INDEX

"FIXES ARE GREAT IN '98"

INTRODUCTION

Figure 7

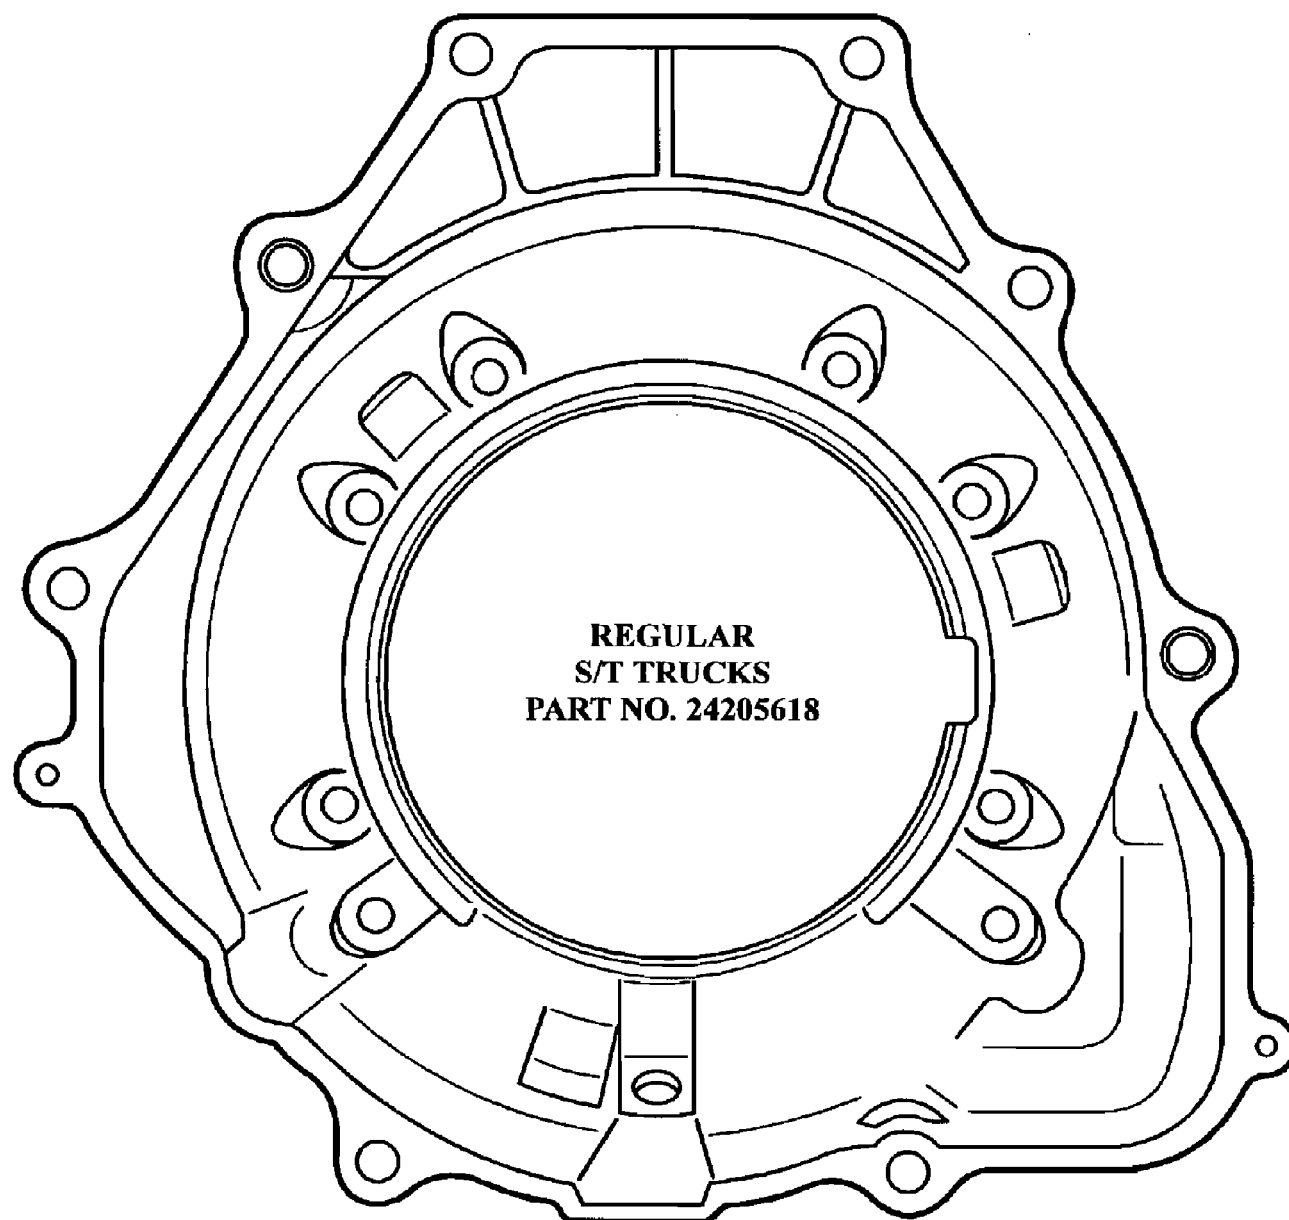
The Bellhousing shown in Figure 7, is the Regular S/T Truck bellhousing used in North America and is cast different than the export S/T Truck bellhousing shown in Figure 6.

Figure 1

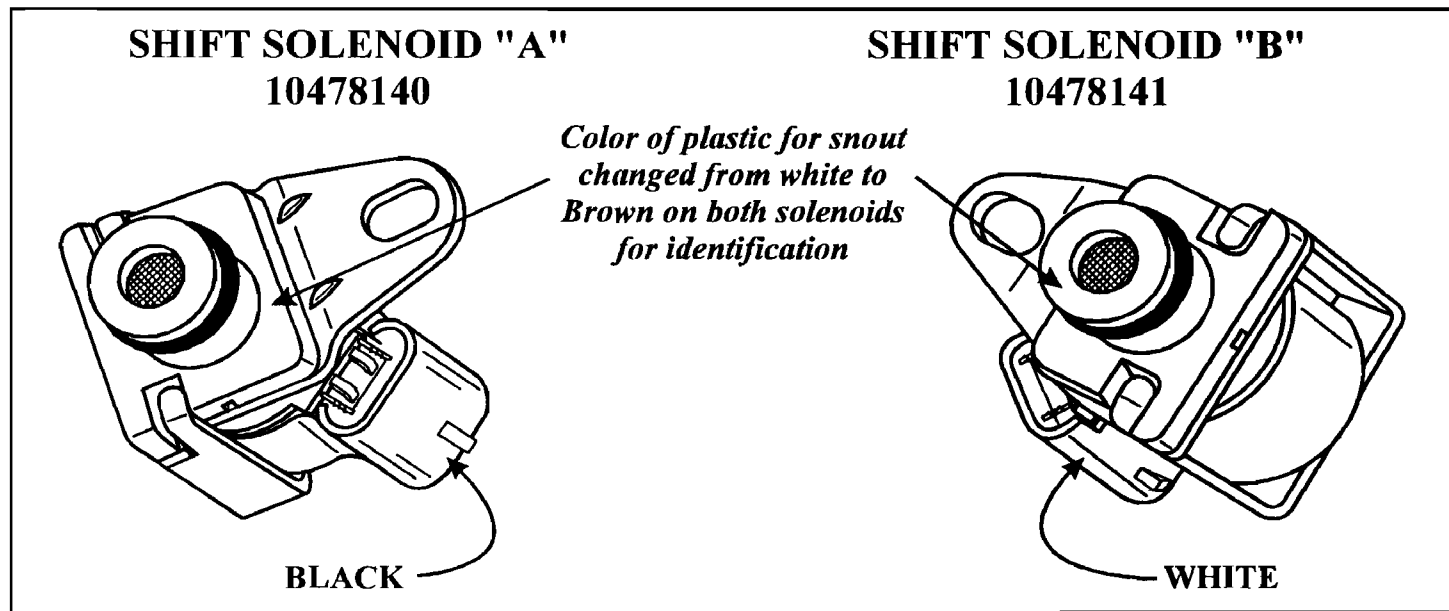
- (1) SHIFT SOLENOID "A" - Revised plastic material in the seat area, and connector is still Black in color, but color of plastic for snout where the "O" ring goes changed to Brown instead of the previous White, for identification purposes (See Figure 1).
- (2) SHIFT SOLENOID "B" - Revised plastic material in the seat area, and connector is still White in color, but color of plastic for snout where the "O" ring goes changed to Brown instead of the previous White, for identification purposes (See Figure 1).
- (3) EPC SOLENOID - Revised (Larger) micron in the solenoid screens for improved operation in cold ambient temperatures (See Figure 2).

Figure 2

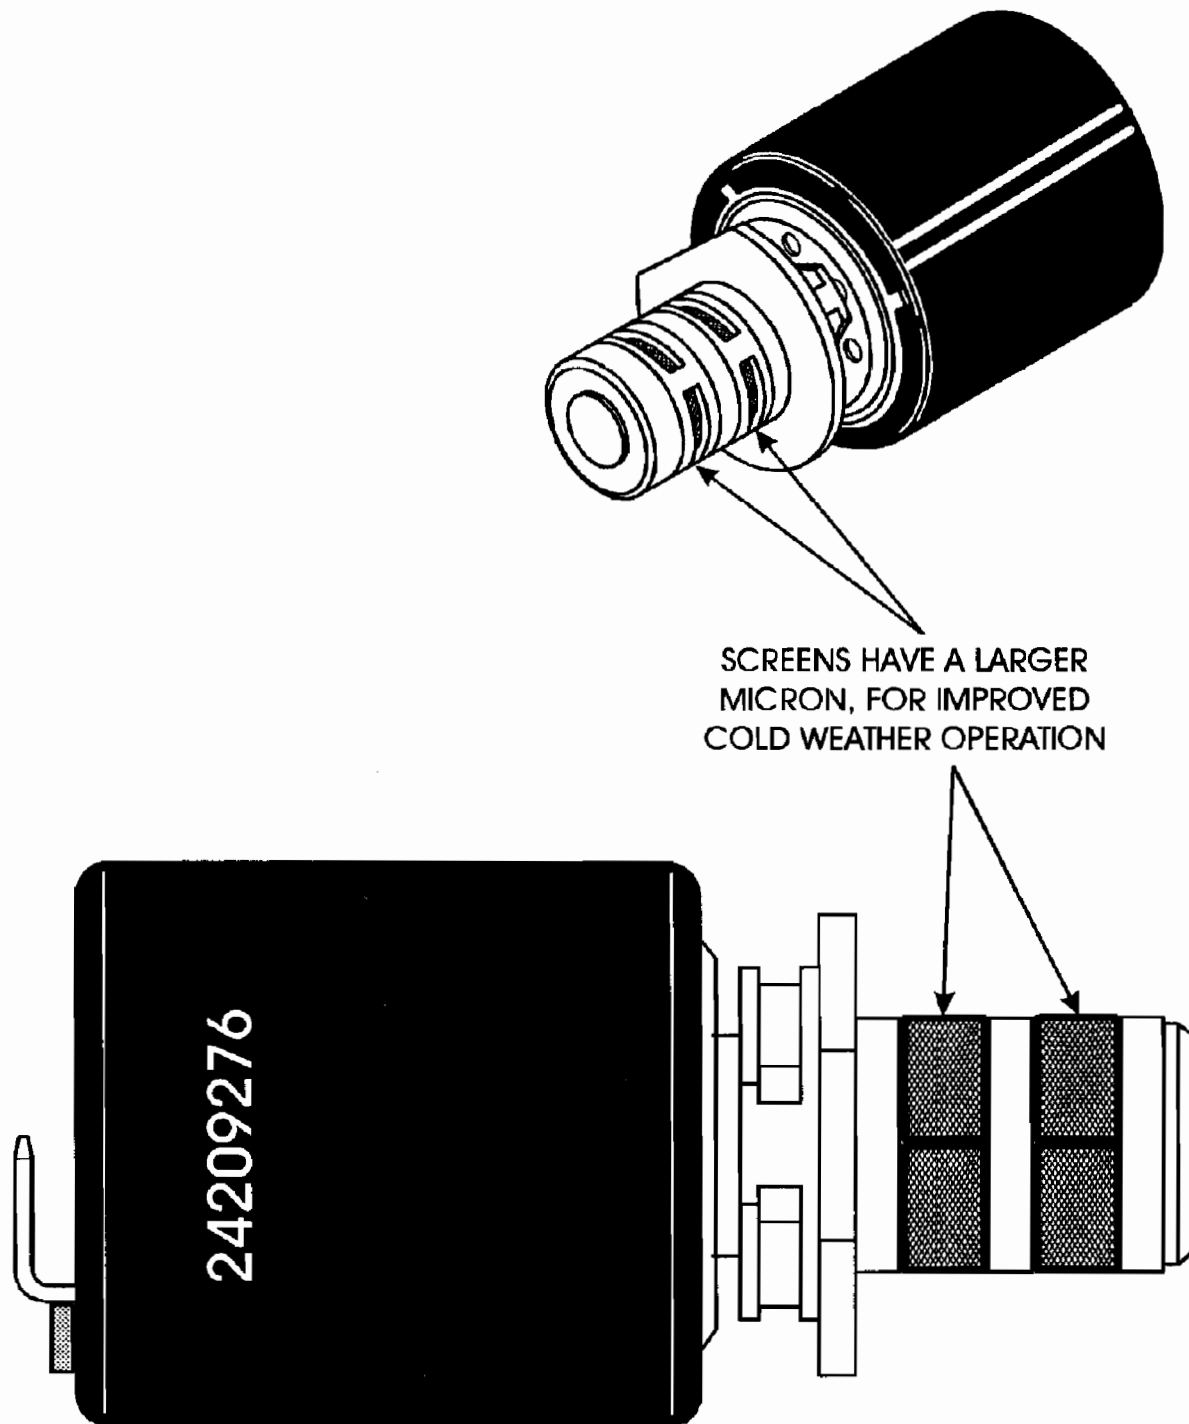
REASON: Revised plastic material for seats in the Shift Solenoids, and larger micron screens in the EPC Solenoid for improved durability.

Figure 1

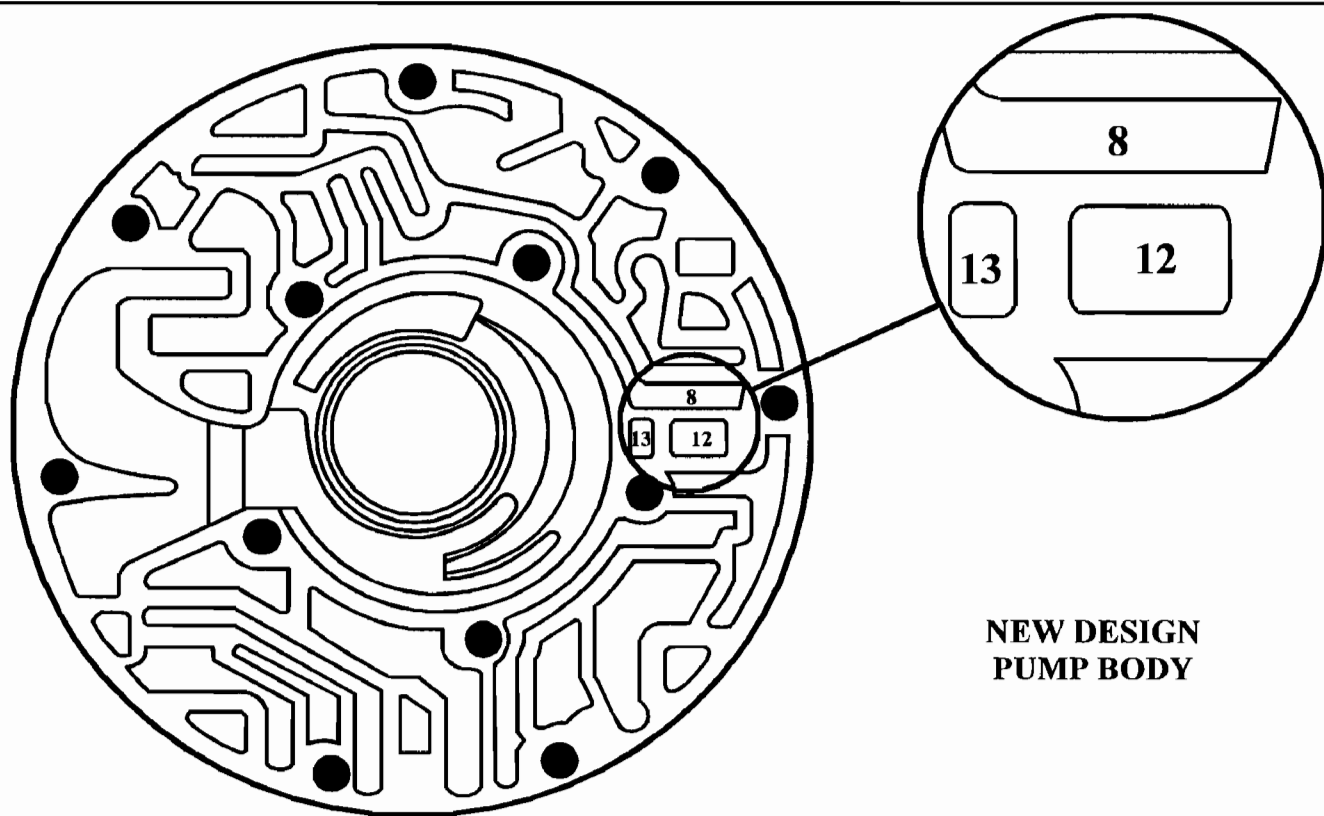
- (3) **FRONT PUMP COVER** - The front lube system is supplied oil by the regulated converter feed oil passage through modifications to the oil pump assembly. One oil pump assembly modification, is a machined .048" orifice slot in the pump cover, connecting regulated converter feed oil to the passage which provides oil to the front lube system (See Figure 1).

Figure 3

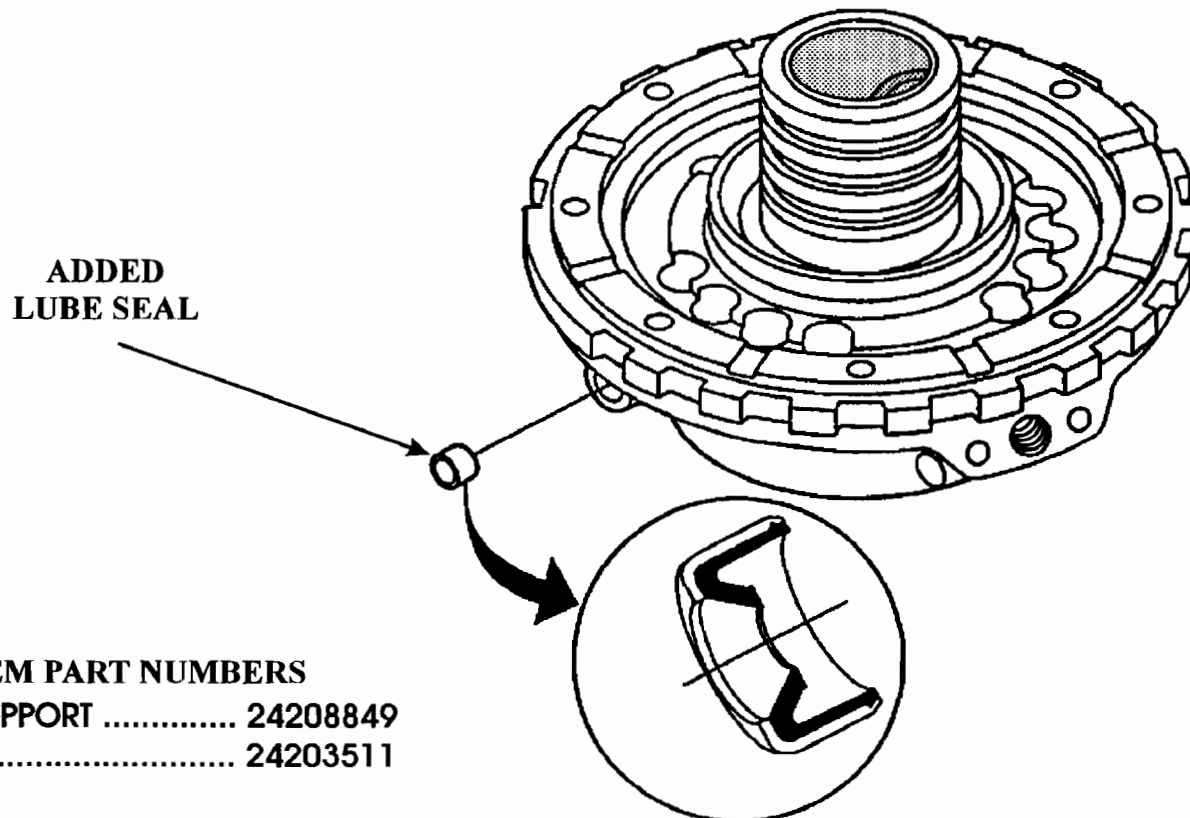
- (2) **CENTER SUPPORT** - A new metal clad lube seal and a new lube passage were added to the center support, as shown in Figure 3. The center support bushing length has been extended and the grooves modified to connect the reaction carrier bushing lube passage to center lube supply at the outer diameter of the sun gear shaft. The intermediate clutch lube orifice was also reduced. Refer to Figure 3.
These changes now require removing the return cooler line fitting, before removing the center support, to eliminate any damage to the related parts.

Figure 4

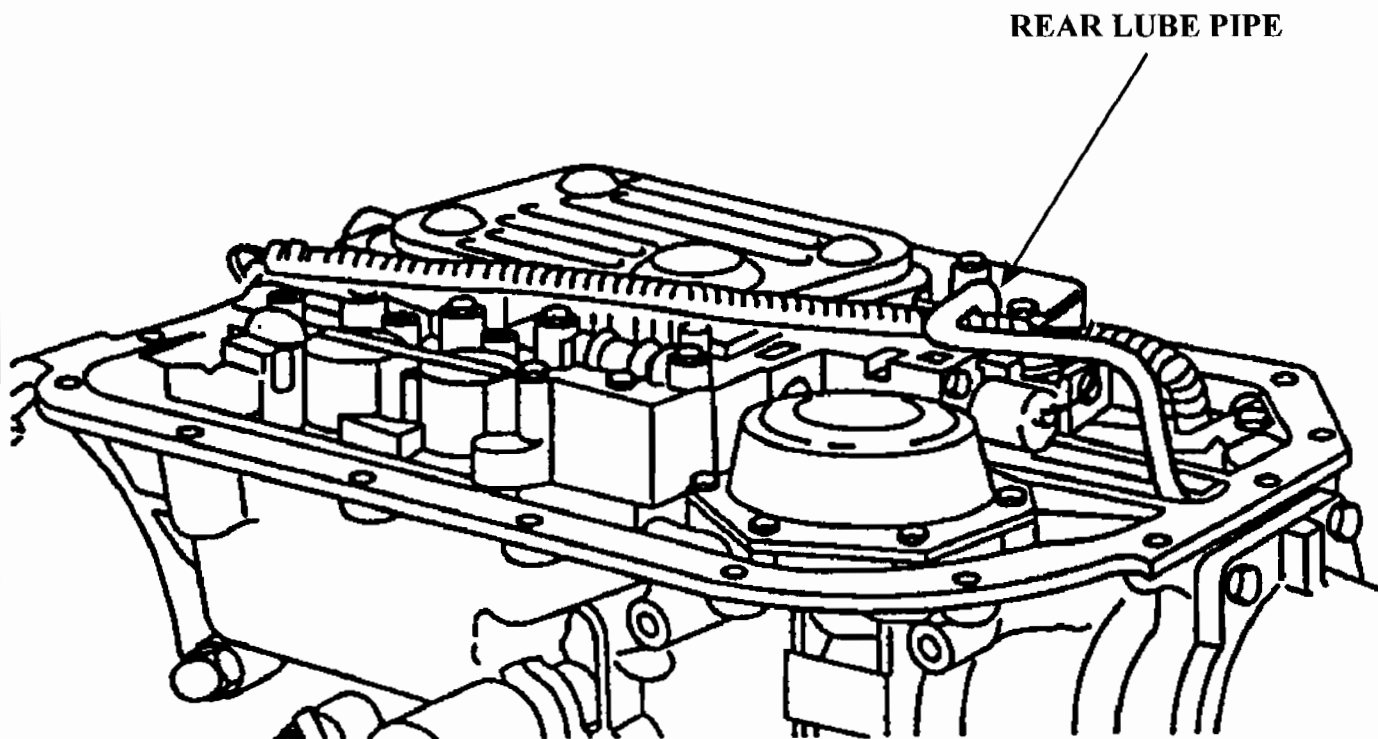
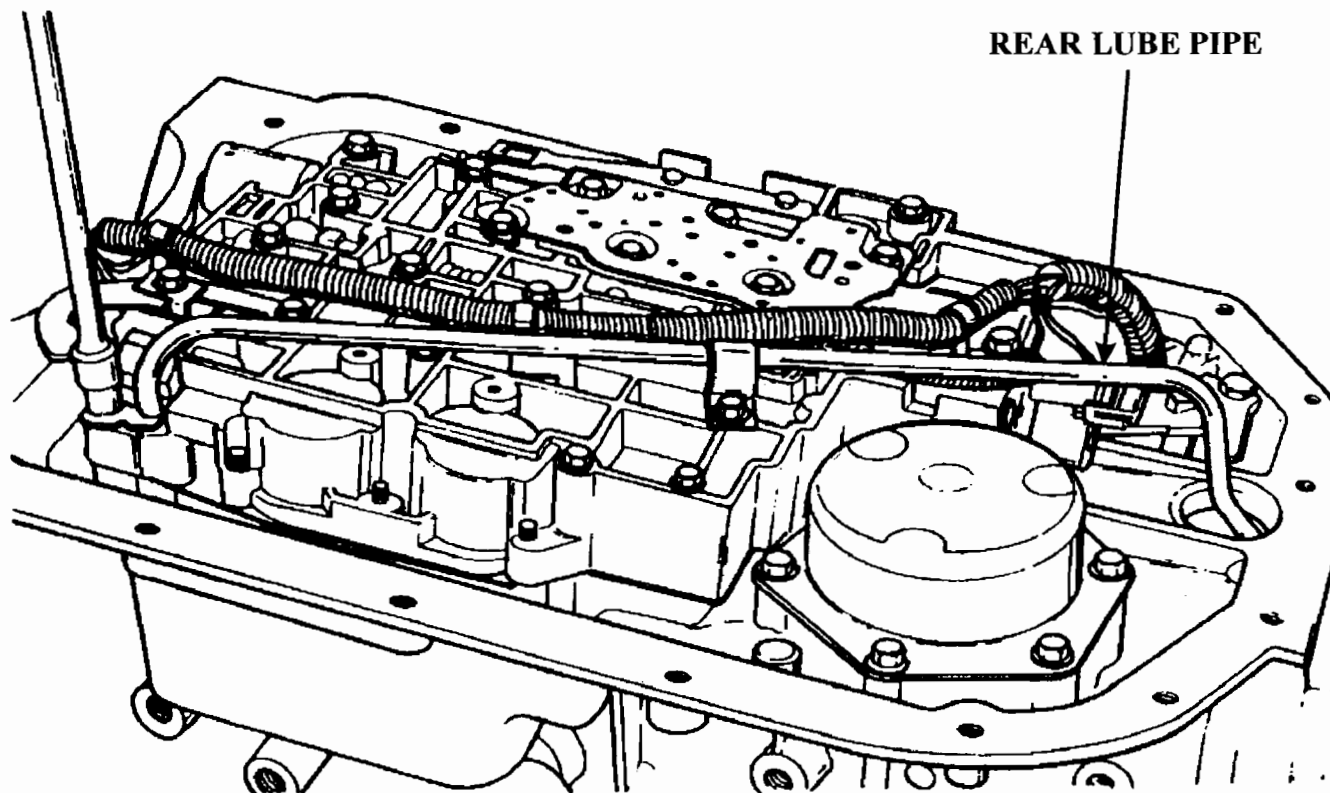
- (5) **VALVE BODY** - Received modifications to accommodate the new rear lube pipe, which provides lubrication to the rear case thrust washer, case bushing and extension housing bushing, as shown in Figure 4.

- (6) **REAR LUBE PIPE** - Has been made shorter, and installed into the actuator feed oil passage at the back of the valve body, as shown in Figure 4. Rear lube is isolated from center lube and provides lube for the rear case thrust washer, case bushing and extension housing bushing.
